**REQUEST**

Current Zoning: B-1 (neighborhood business)  
Proposed Zoning: MUDD(CD) (mixed use development district, conditional)

**SUMMARY OF PETITION**

The petition proposes to allow a new freestanding bank branch facility with one (1) walk-up ATM. The site is currently developed with a gasoline/service station and is located north of the intersection of Providence Road and Queens Road.

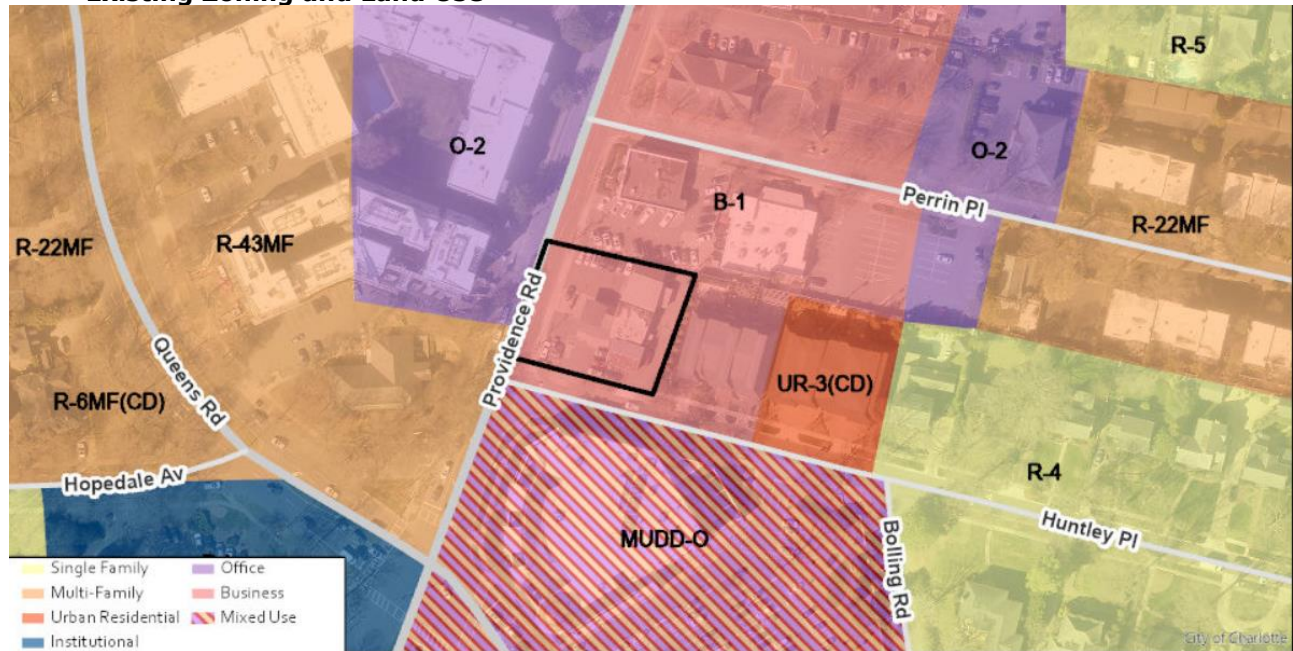
1. Petitioner should revise the site plan to provide a sidewalk transition prior to the curb ramp at the intersection of Providence Road and Huntley Place.

2. Revise architectural standards note to state building will meet MUDD architectural standards.

3. Remove the following language from Tree Save Area Note f.a: "*Plantings from perimeter buffers and internal parking lot landscaping to be credited, not in addition to.*"
4. (Ref. Tree Save Area Note f.a.) Petitioner must show the tree save area first. This will be 15% of total site area, then calculate how many trees will be planted in that area.  $0.31 \times 15\% = .0465$  acres will need to be designated as replanted tree save area. Please provide 2 trees in that area. These trees do not count toward internal, perimeter or buffer trees.

5. Modify Note d under *Development Data* heading and Note b under *Purpose* heading to read MUDD(CD).
6. Remove Flood Zone information.
7. Label multi-use path and planting strip along Providence Road, and sidewalk and planting strip along Huntley Place. Provide development notes committing to these improvements, including widths.
